Subject: Virgil C. Summer Nuclear Station (VCSNS) Units 2 and 3 Combined License Application (COLA) - Docket Numbers 52-027 and 52-028 Response to NRC Request for Additional Information (RAI) Letter No. 024

Reference: Letter from Ravindra G. Joshi (NRC) to Alfred M. Paglia (SCE&G), Request for Additional Information Letter No. 024 Related to SRP Section 6.4 for the Virgil C. Summer Nuclear Station Units 2 and 3 Combined License Application, dated January 22, 2009.

**NRC RAI Letter No. 024 Dated January 22, 2009**

**SRP Section: 06.04- Control Room Habitability**

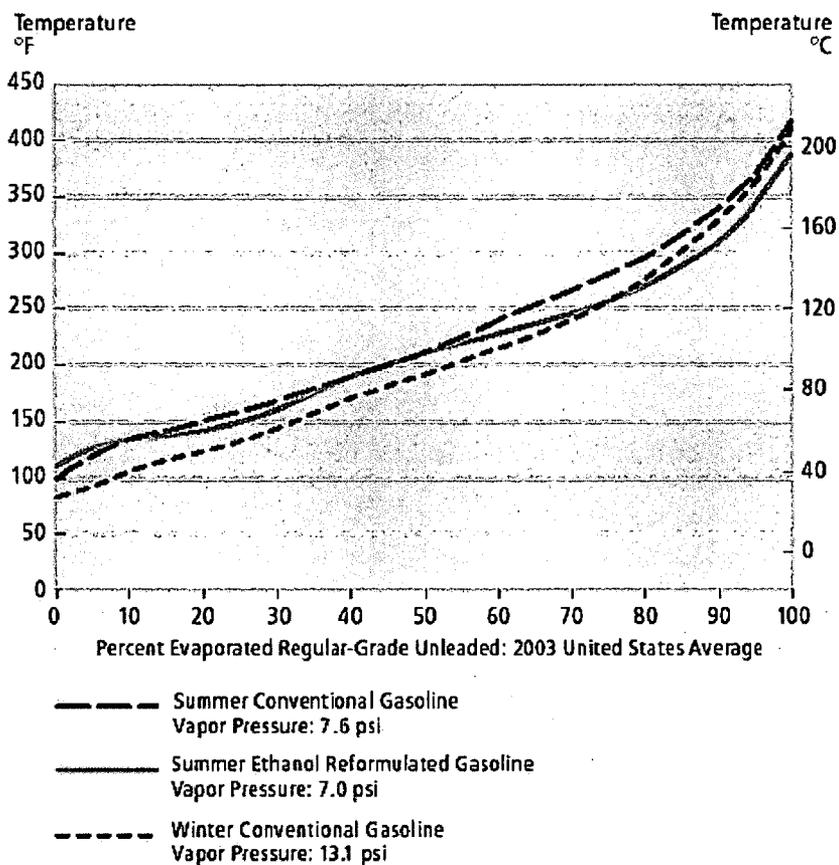
**Note 1:** As recommended by the U.S. Environmental Protection Agency (US EPA), gasoline was modeled for vapor cloud explosions by selecting n-Heptane in ALOHA's chemical library. As indicated in correspondence from Len Wallace of the US EPA, gasoline contains hundreds of hydrocarbons (Wallace 2007). Because of this, gasoline boils over a range of temperatures—the boiling point of gasoline is listed as a range, 140-390°F (CHRIS 1999). At the lower end of range of gasoline's boiling point, only a small fraction of the gasoline would be able to evaporate and form a vapor cloud. It was assumed that the entire quantity of gasoline, 12,000 gallons, was modeled as n-Heptane and therefore available to form a vapor cloud. Below is an excerpt from that correspondence from the US EPA (Wallace 2007), along with a provided distillation graph.

Gasoline VP range is 38-300 mmHg (NIOSH)

Just three chemicals from Gasoline: Butane 760 mmHg

Ethanol 40 mmHg

N-Heptane 37 mmHg

300 mmHg is the mid range
